CHANGE ORDER APPROVAL FORM

PROJECT: Blackrock Road Corridor Improvements CHANGE ORDER NUMBER: 4
 DATE: 6-3-14
 CONTRACT NUMBER: CM2034
 TO CONTRACTOR: Petticoat-Schmitt Civil Contractors Inc.

CHANGE ORDER REQUEST FORM

Blackrock Road Corridor Improvement Project

SHEET NO.	33
-----------	----

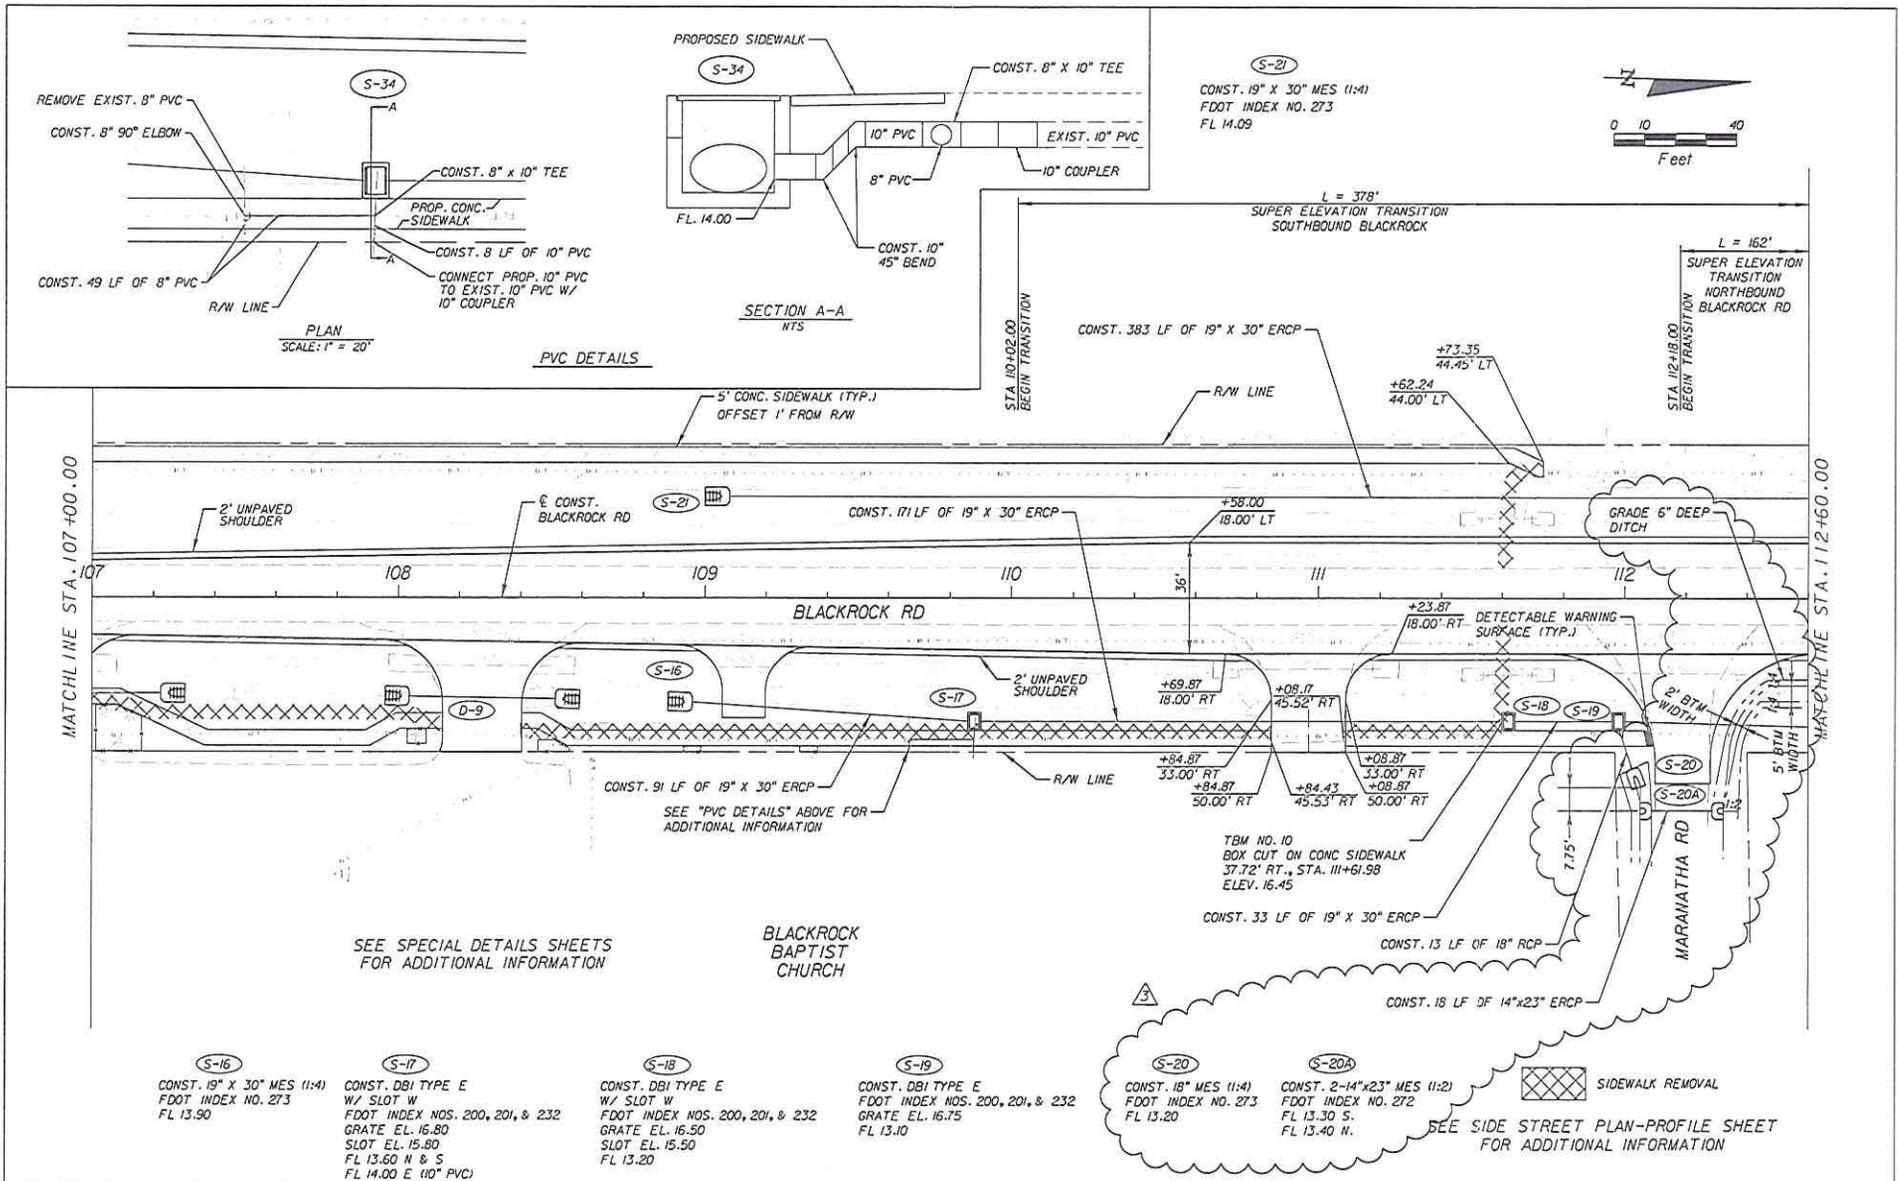
Based on the plans, see plan sheets 33 & 34 (attached), the SE corner of Maranatha Rd. will drain into a new MES (S-20) then down to structure S-19, to S-25, across Blackrock Road and pop off into the drainage easement at MES S-24. This should enhance the current drainage condition.

REVISIONS	
DATE	DESCRIPTION
04-05-2004	ADDED CROSS DRAIN UNDER MARIATHA RD; ADDED DITCH GRADING ON N. SIDE OF MARIATHA RD; UPDATED F.L. OF S-20

SHEET NO.
23

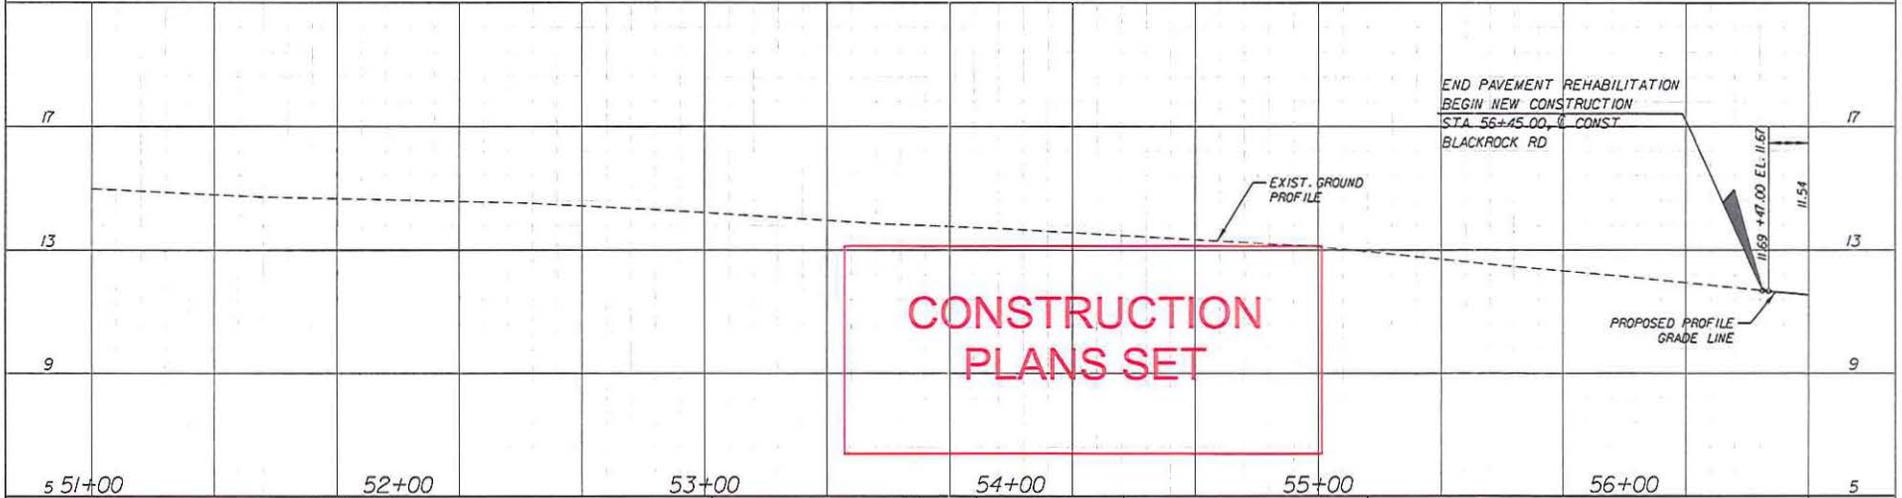
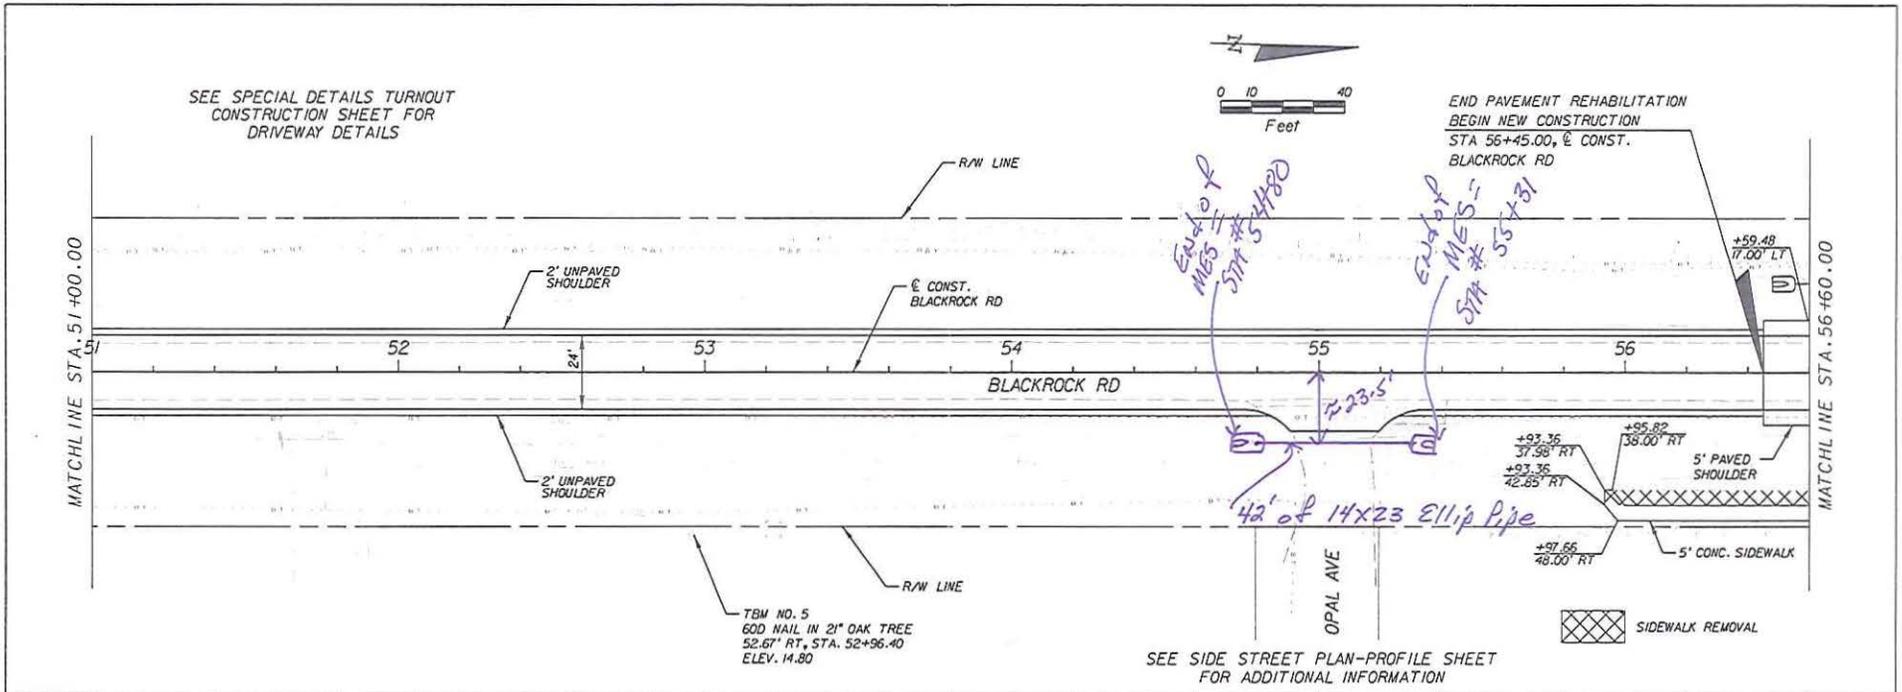
Per Nassau County's request we need to add a pipe crossing at Opal Avenue. Attached are the marked up plan sheets providing all information necessary for the installation.

Nassau County would like to replace the existing 15" CMP that crosses Opal Ave. due to its poor condition. In the original Bid Set of plans we called for this pipe to be replaced with 42 LF of 18" RCP at an offset of 30.39' Rt. with Flow Lines at 10.31 BK and 10.05 AH. Since the side street profile changed to a lower elevation profile in the Construction Set of plans I think that 14" x 23" Elliptical pipe would be the best way to go. In addition, since we are not going back into the side street nearly as far as we were going to, my thought is to have the pipe installed at an offset of approximately 23.50' Rt., thus aligning the new pipe run with the existing ditch line. Also, based on the limited amount of cover, I think that the original Bid Set flow lines of 10.31 BK and 10.05 AH would still be appropriate. See attached.

SHEET NO.
33

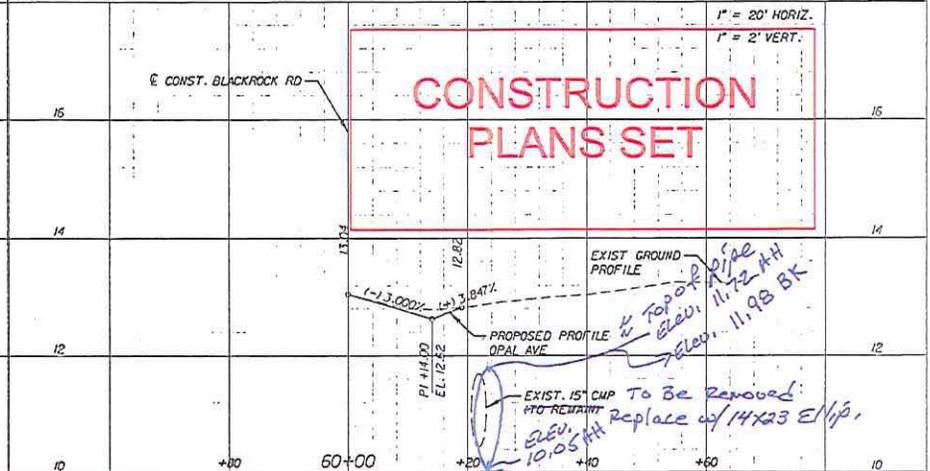
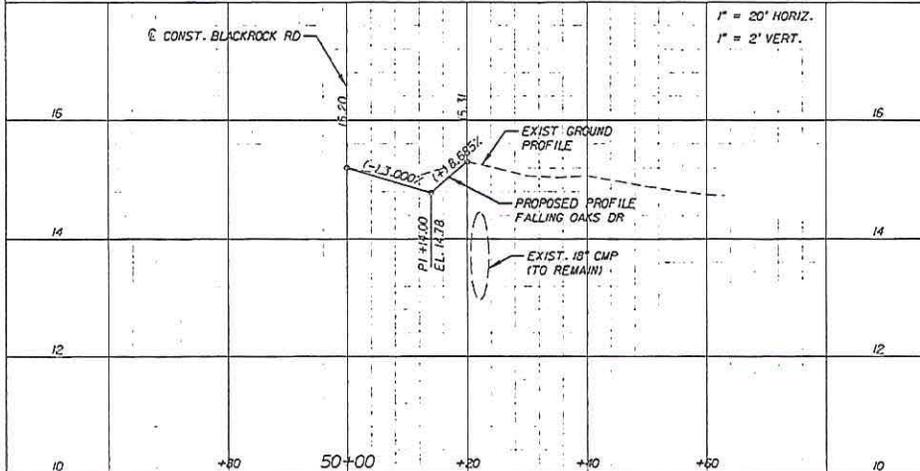
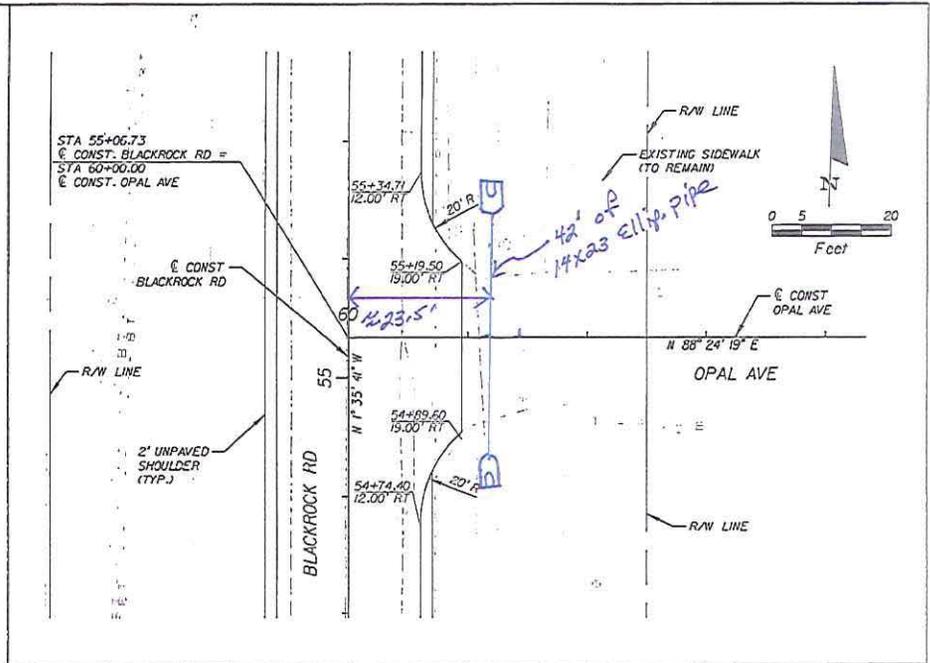
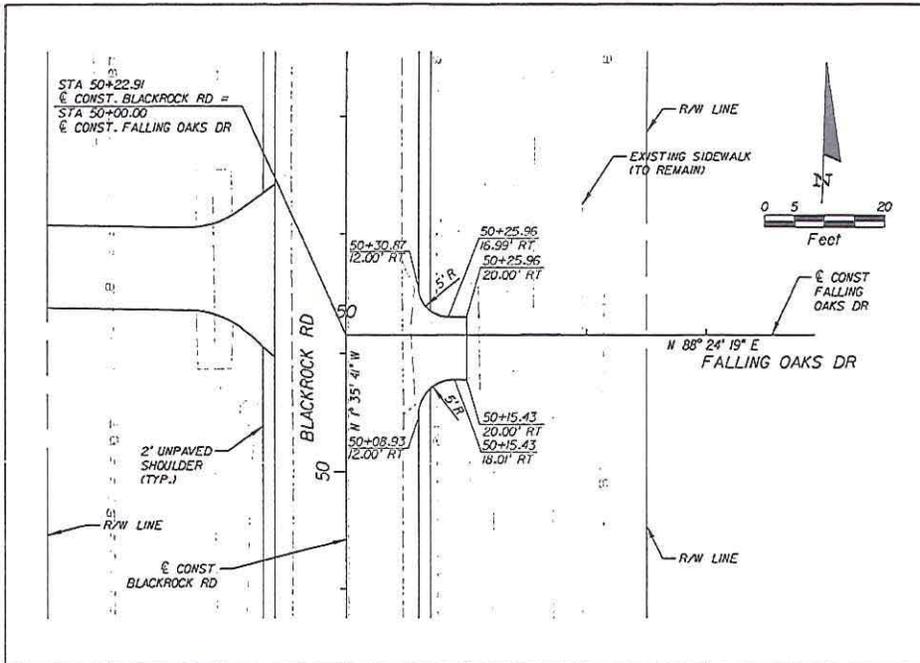
Based on the plans, see plan sheets 33 & 34 (attached), the SE corner of Maranatha Rd. will drain into a new MES (S-20) then down to structure S-19, to S-25, across Blackrock Road and pop off into the drainage easement at MES S-24. This should enhance the current drainage condition.

SHEET NO.
23

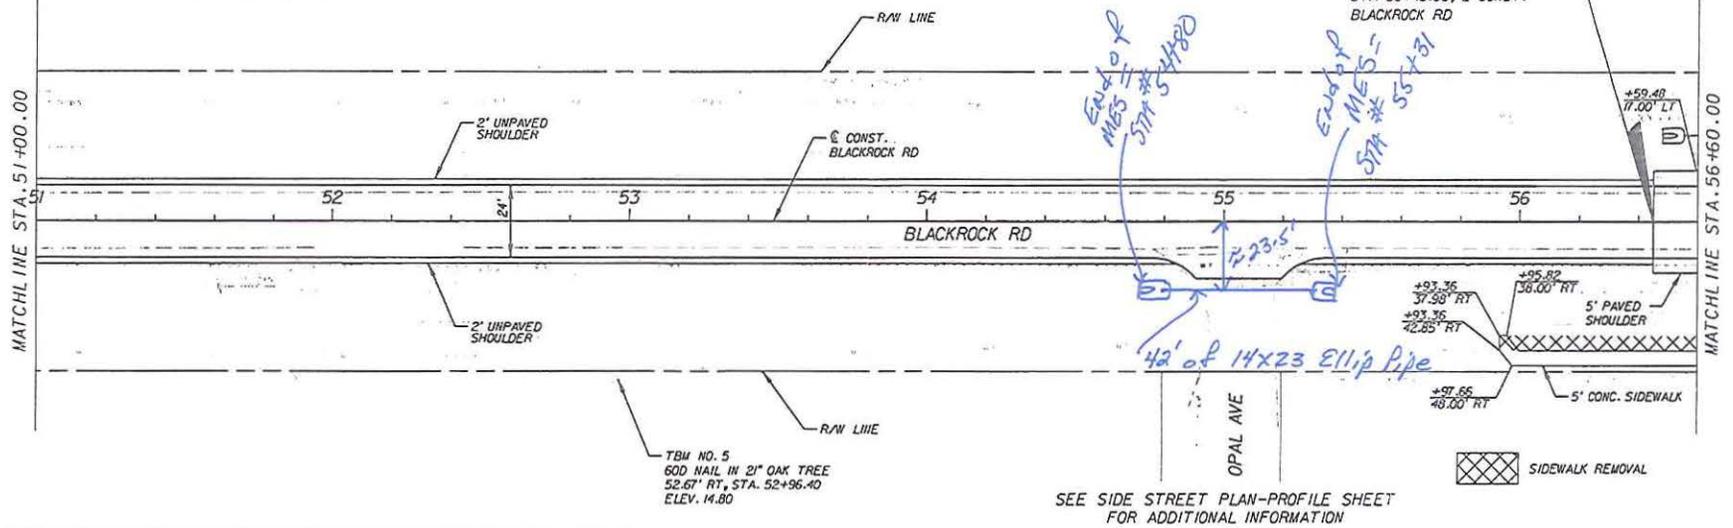
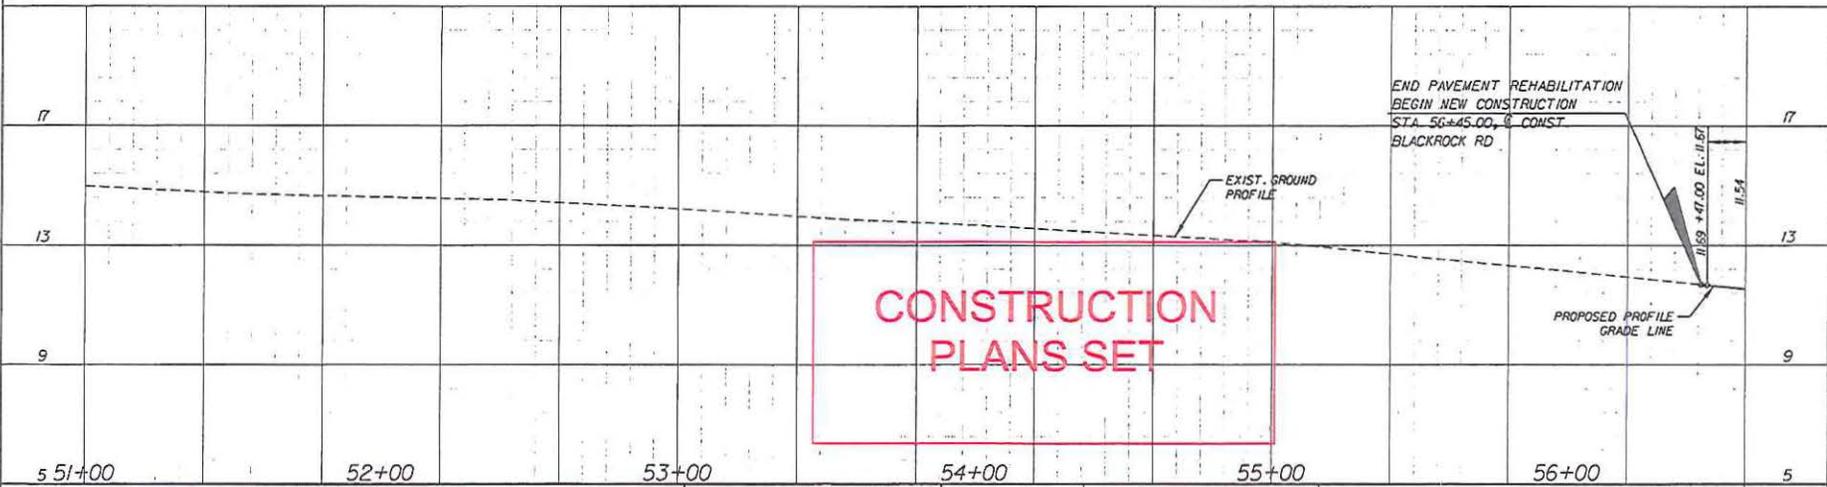
The response that was prepared for RFI No. 3 is still valid. The pavement design for the widening area is shown in Typical Section 1 (Sta 12+14.50 to Sta 56+45.00) and Typical Section 4 (Sta 102+00 to 122+38.00). These widening areas are shown in the plans as "Homogenous Full Depth Reclamation Base" with Type SP-9.5 Structural Course (Traffic C)(2"). All widening for Blackrock Road is being called for by using this homogenous mix with the FDR Process. Additional details for all widening areas are included in the FDR Specs - Widening Section 32 12 04-4. The pavement design that is listed below only refers to the approach areas north and south of the bridge. Thanks.
